Planning Commission

Wednesday, February 5, 2025

CLARKWOOD ESTATES PHASE 1 (PRELIMINARY OF 51.47 ACRES)

**Merged Document Report****Application No.: PL8294**

PRELIMINARY UTILITIES
SCHEMATIC

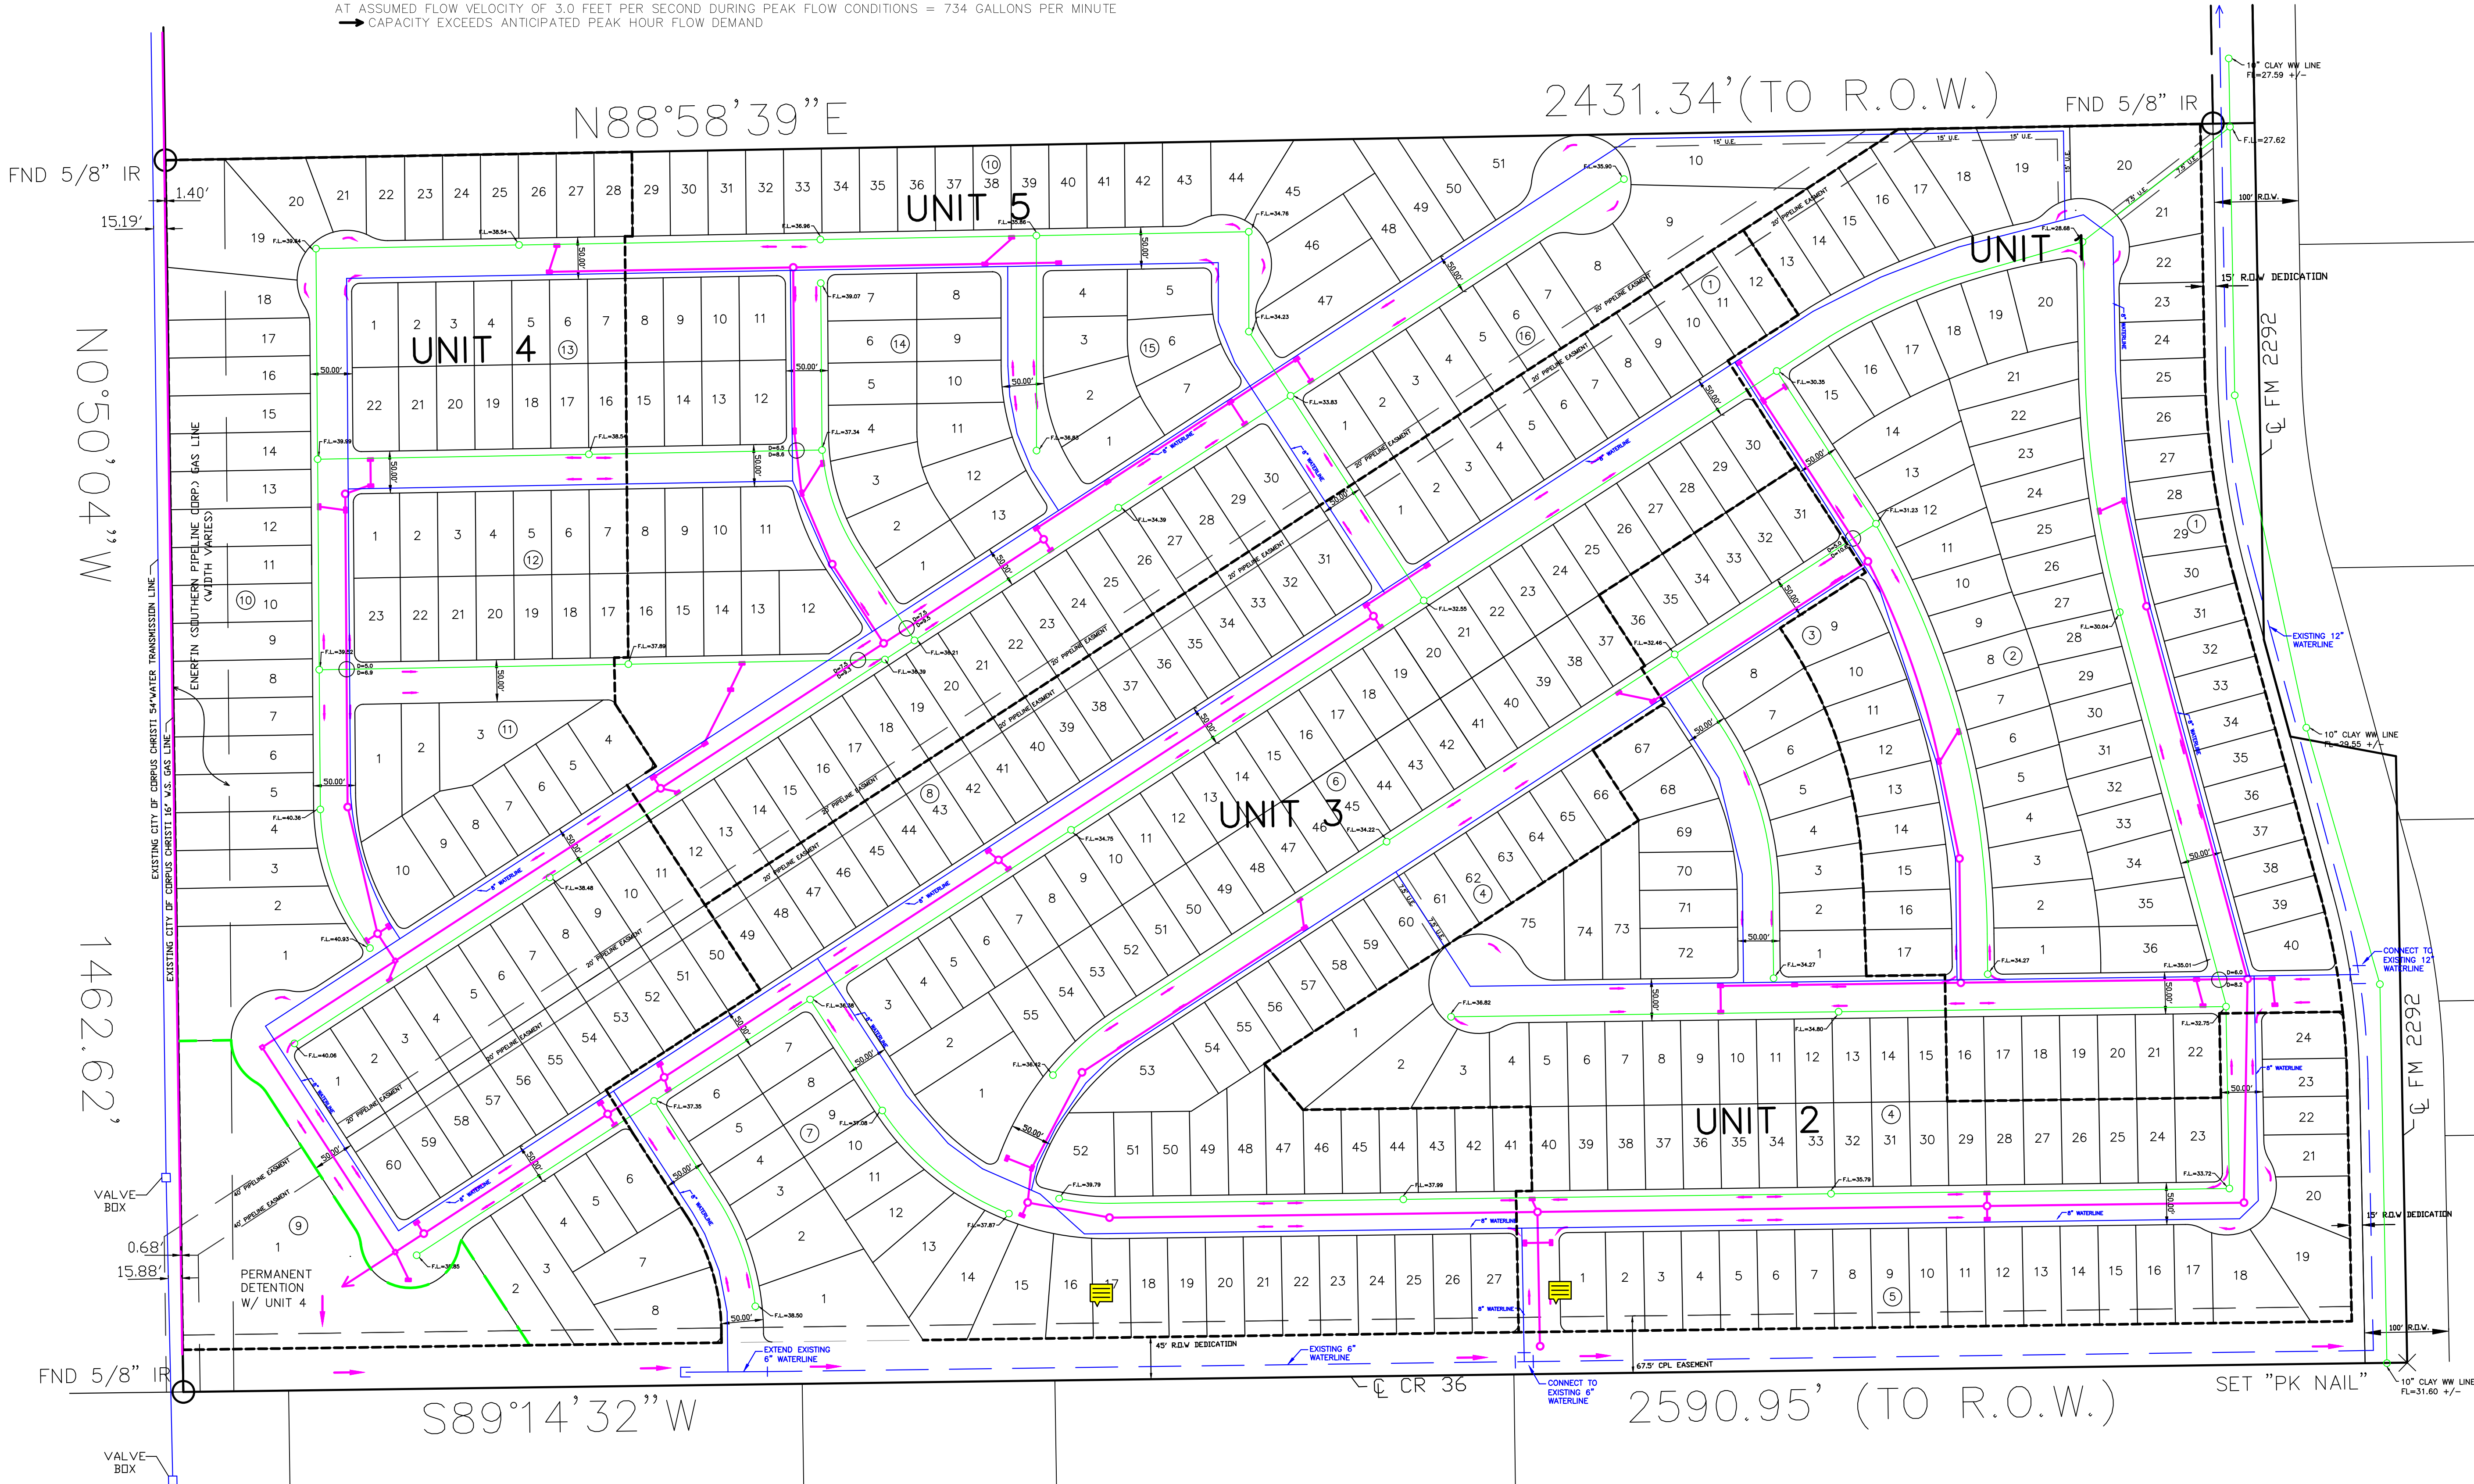
33	utility	Note	John Gonzales : WW	Closed	Wastewater construction is required for platting (UDC 1.2.1.D & 8.2.7; Wastewater Collection System Standards)	
34	utility	Note	John Gonzales : WW	Closed	Please provide estimated wastewater demand for plat.
